July 1, 2021

ADDENDUM No. 1

Oregon Central Fire Station

S2.0

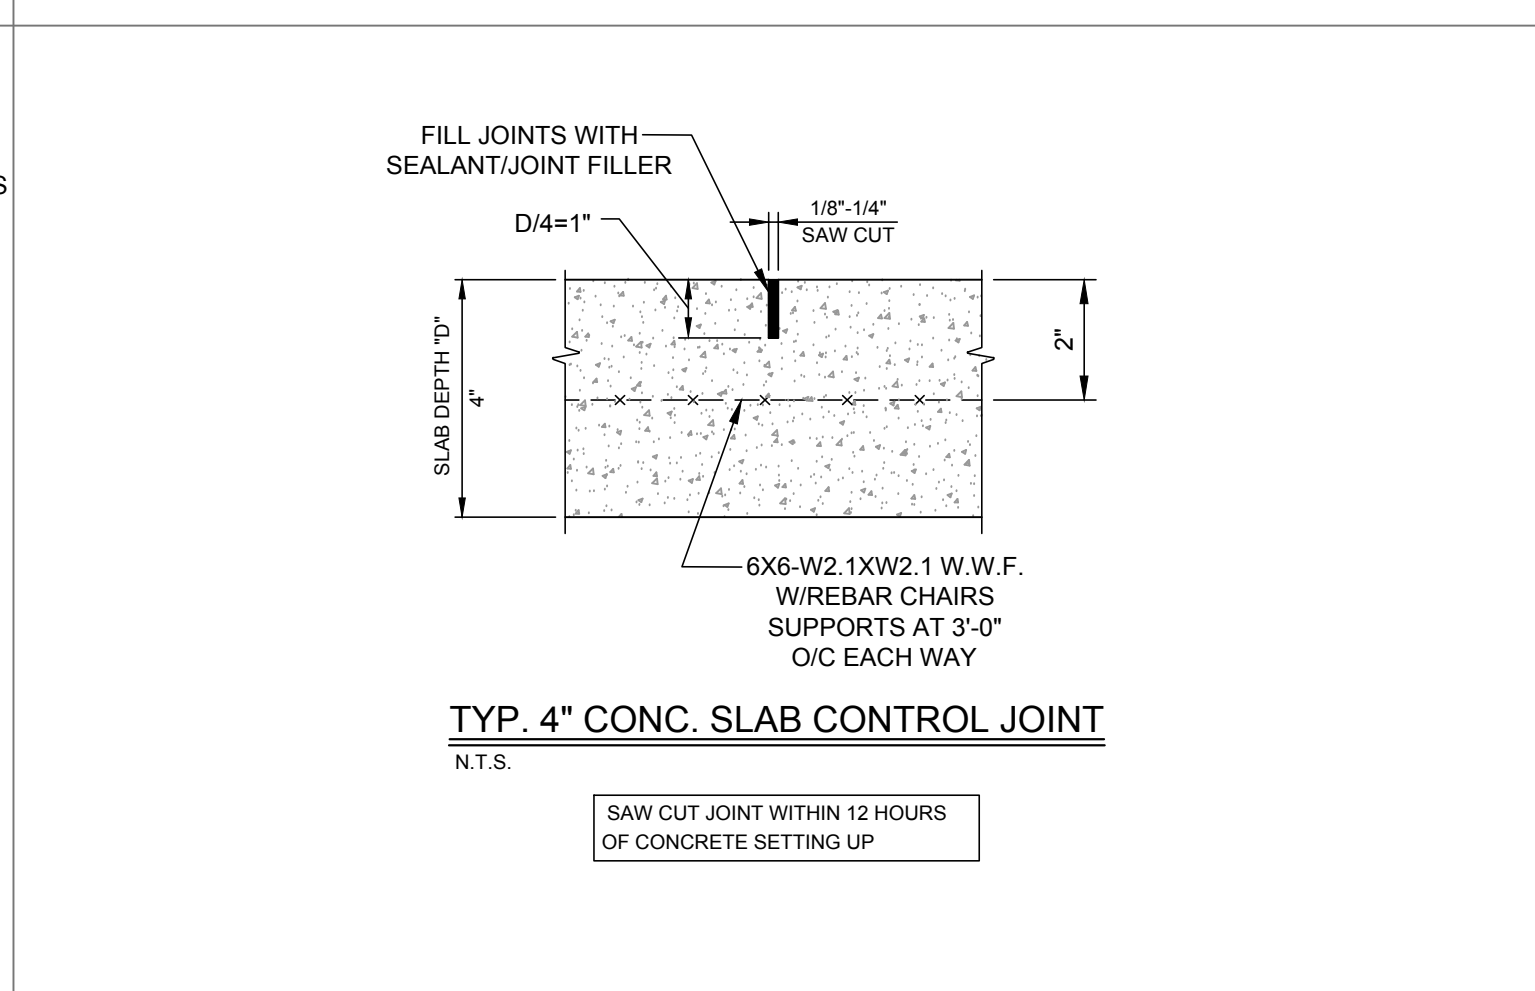
- See attached revised drawing S2.0 for window lintels.

M1.1

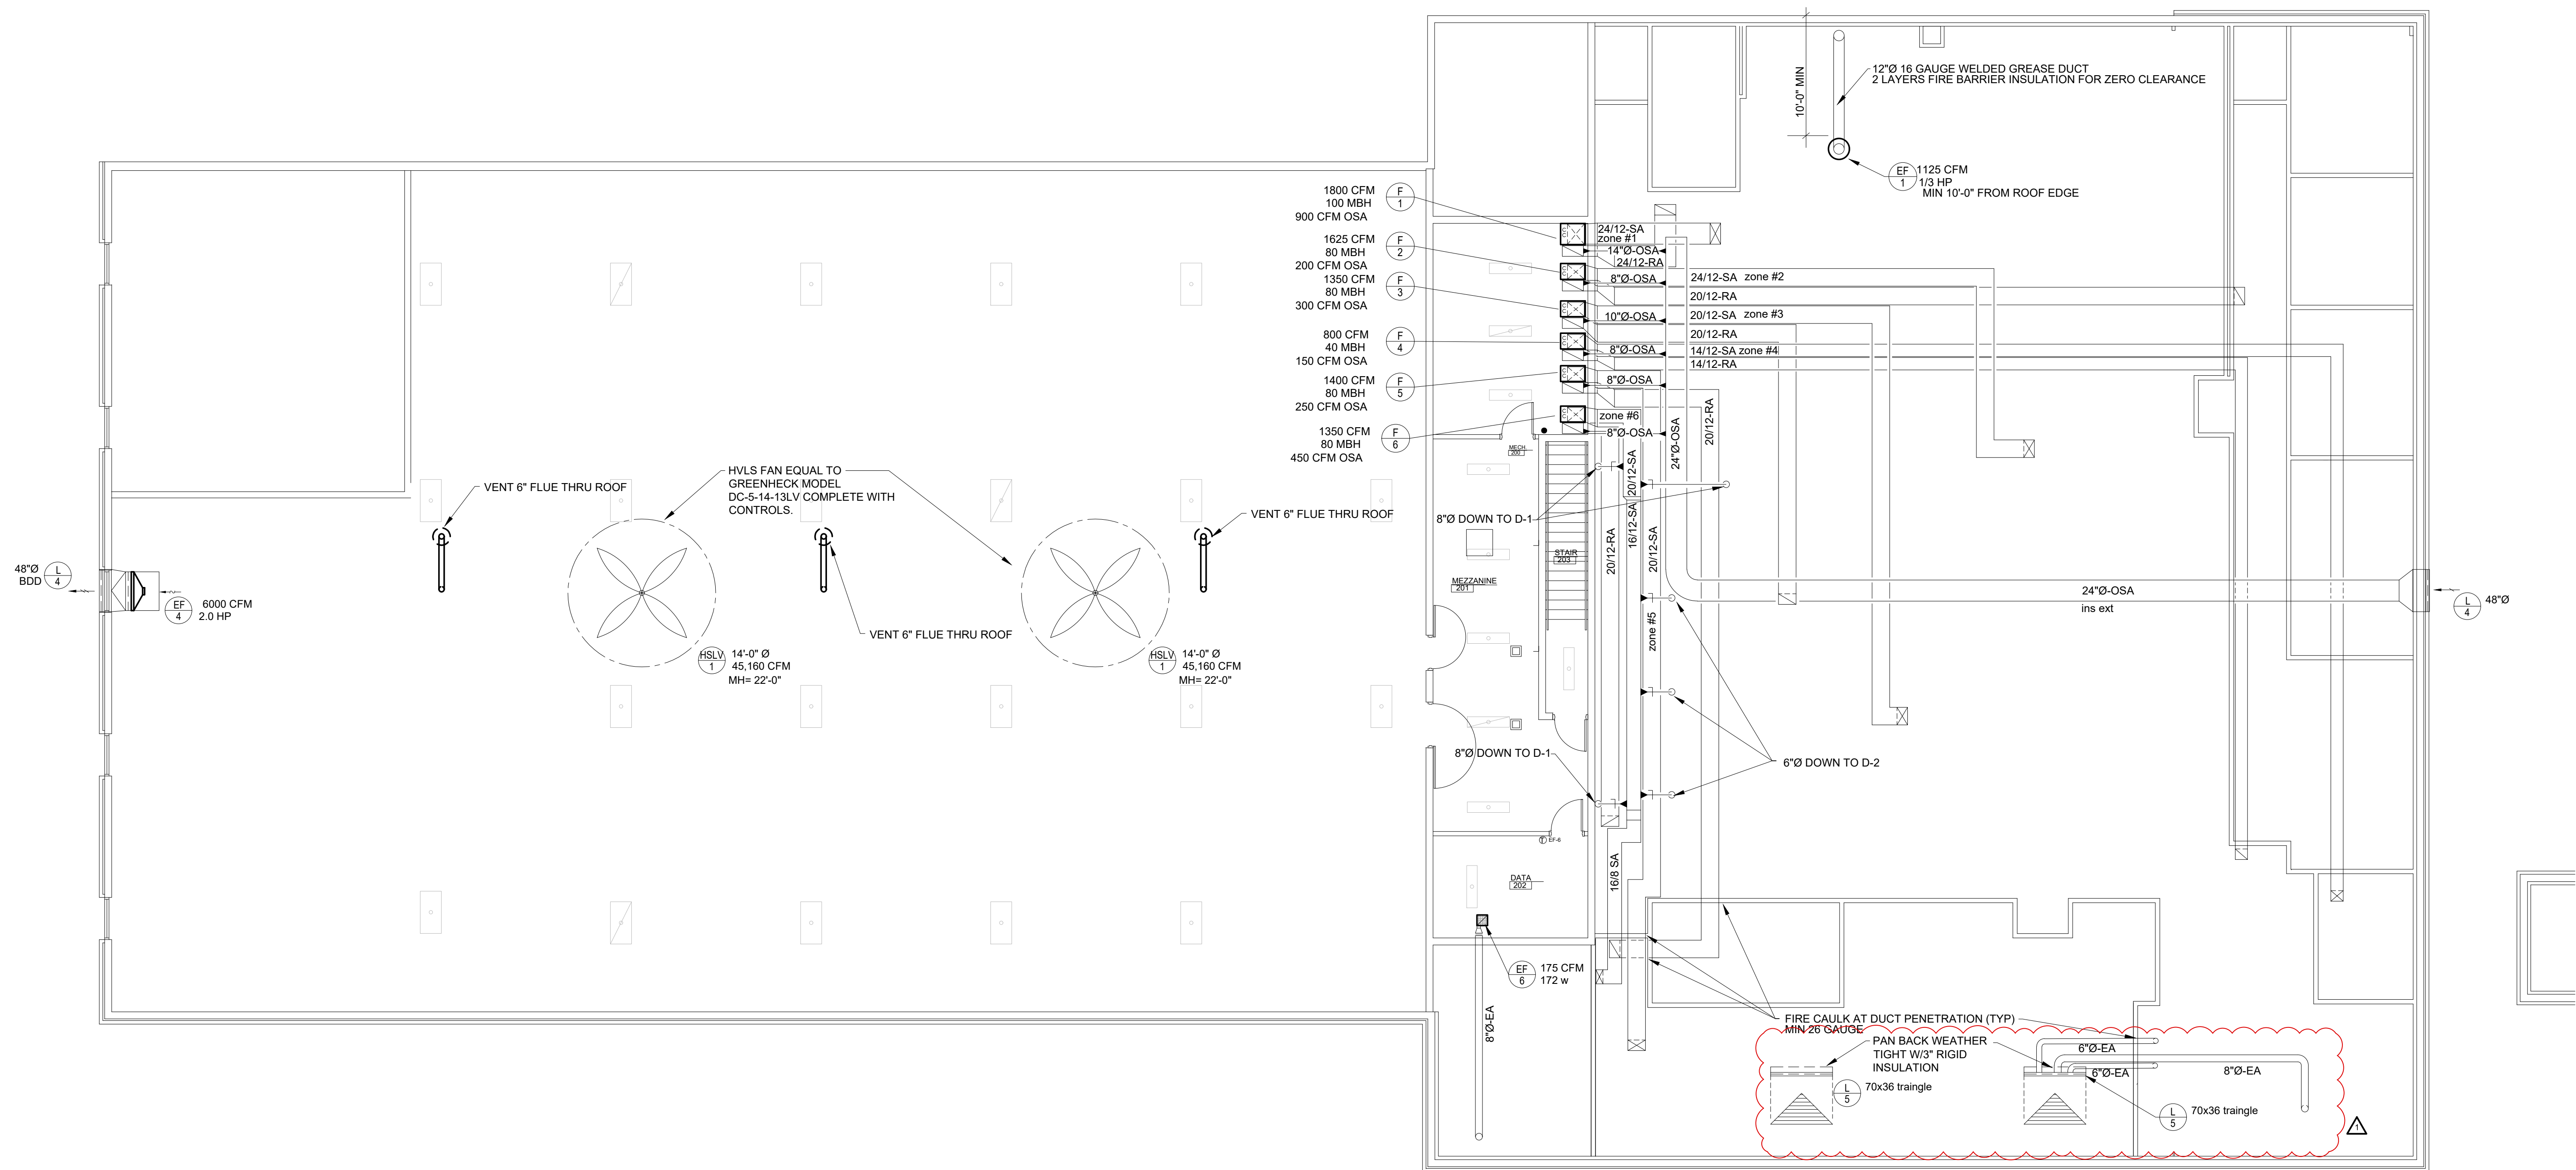
- See attached revised drawing M1.1 for elimination of brick (3) vents and modification of exhaust terminations for exhaust fans EF-1.

M2.0

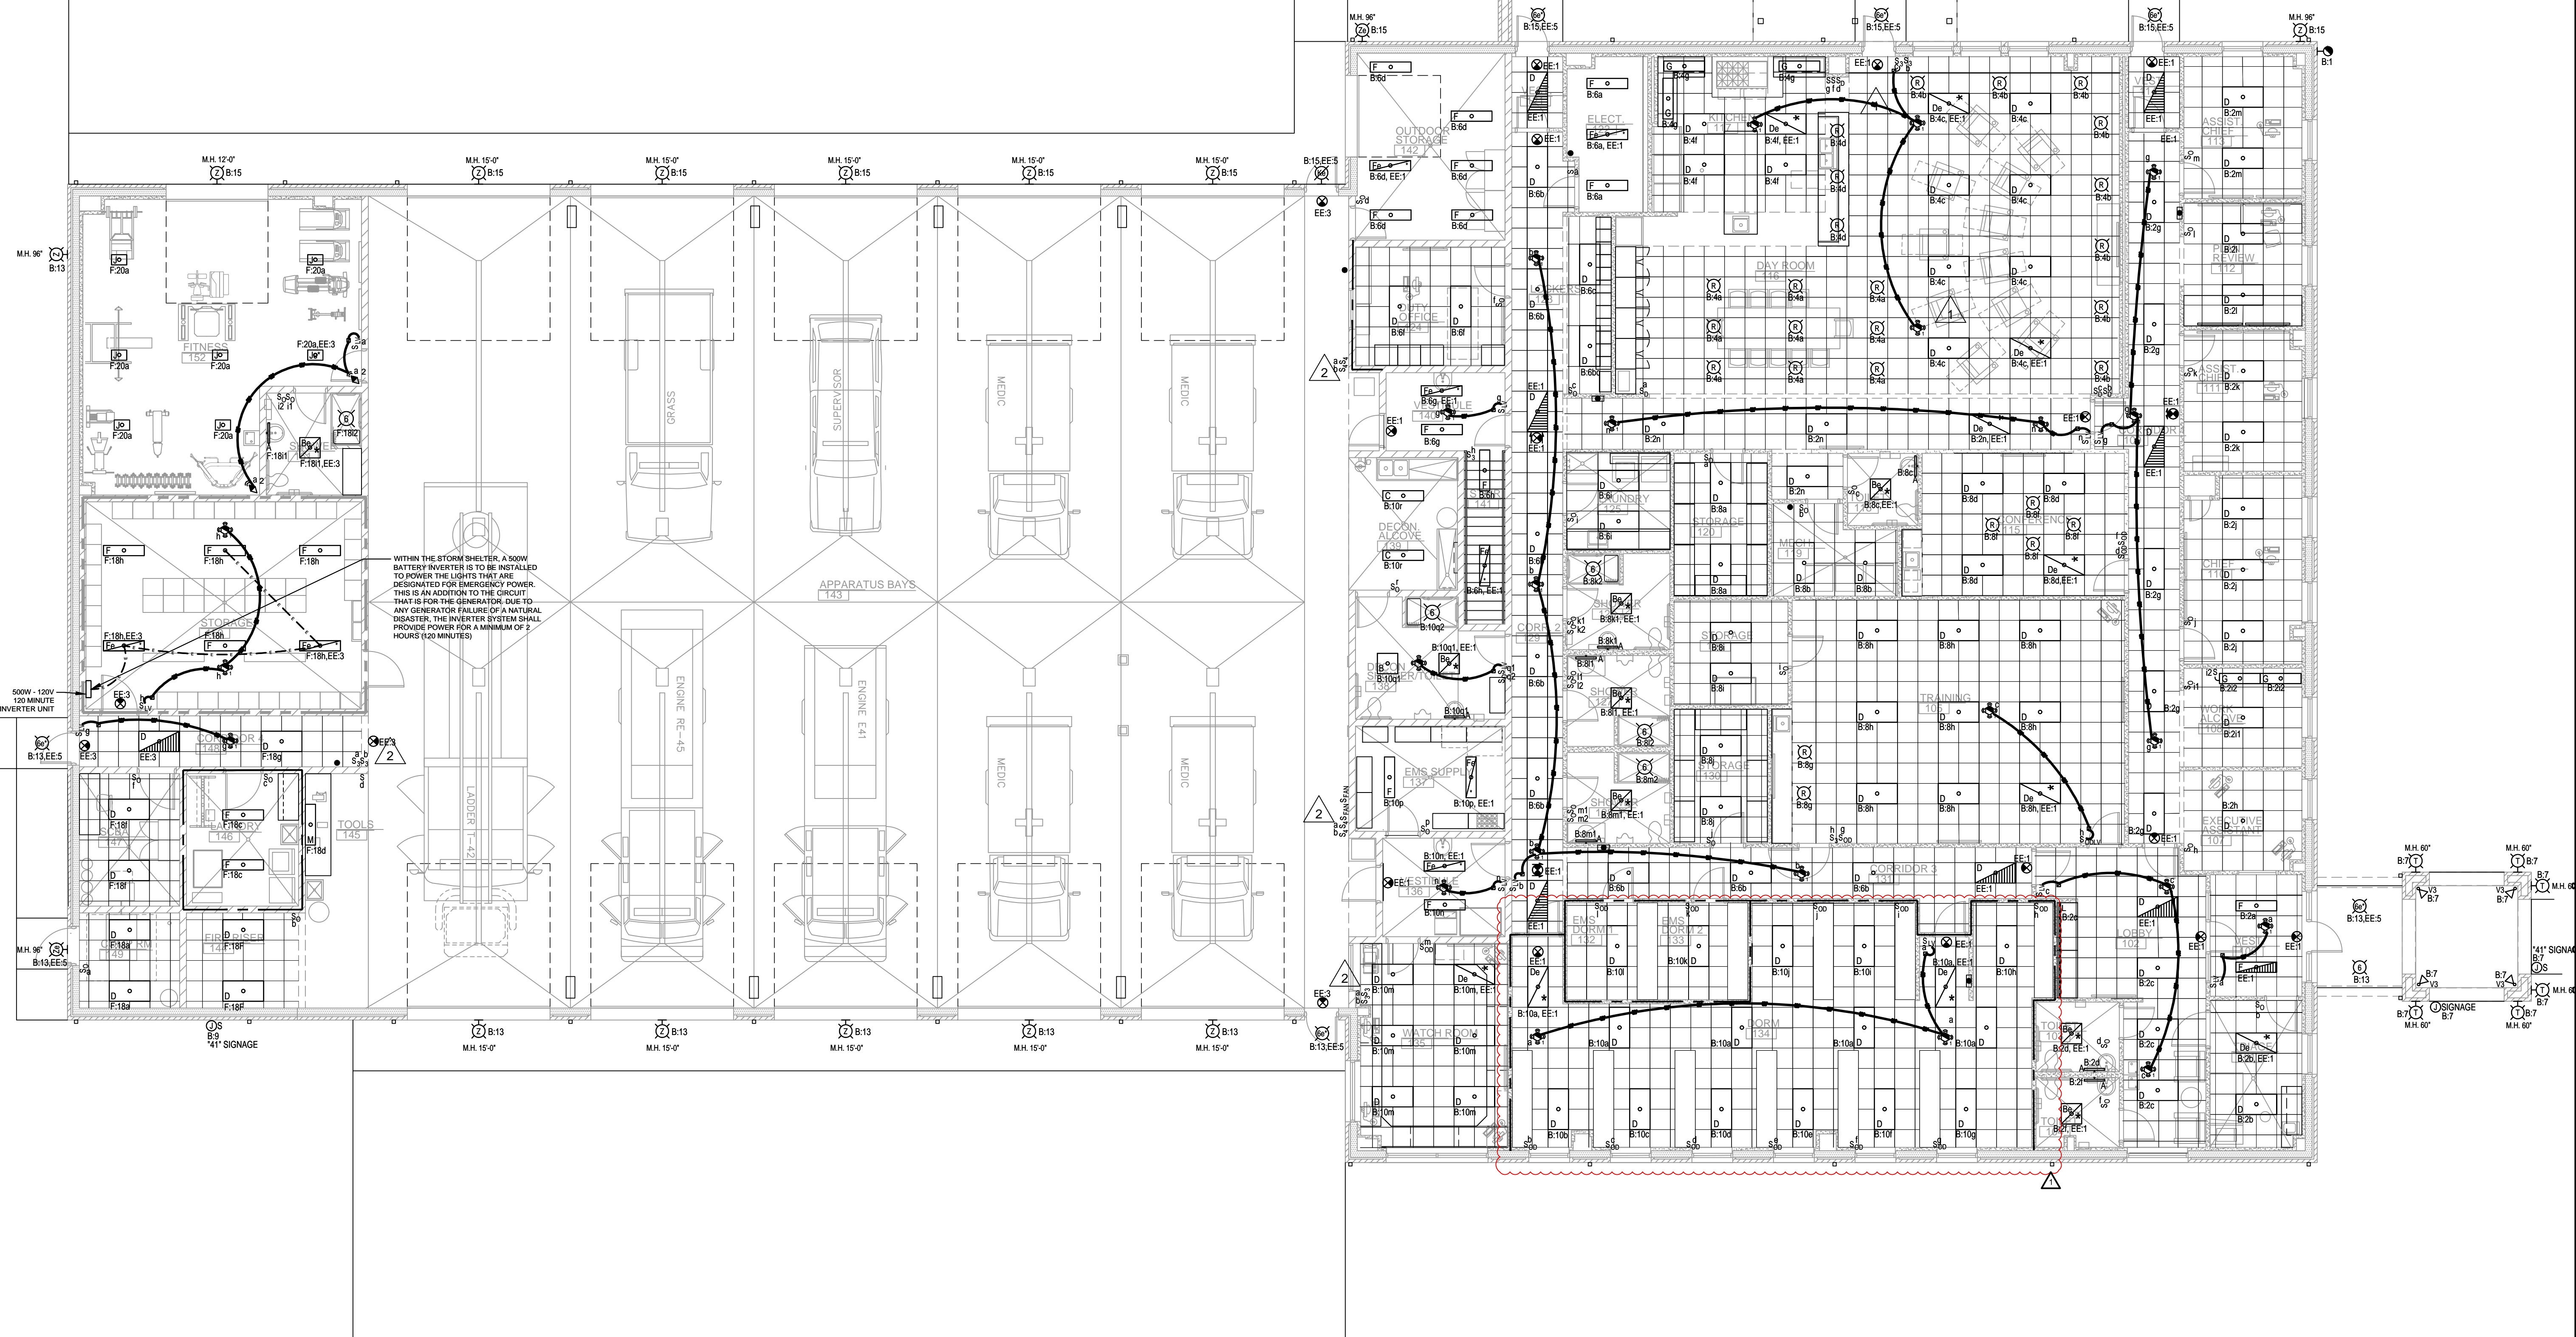
- See attached revised drawing M2.0 for modifications of schedules for condensing Units, Heat pump VRV, Louvers and Exhaust fans.
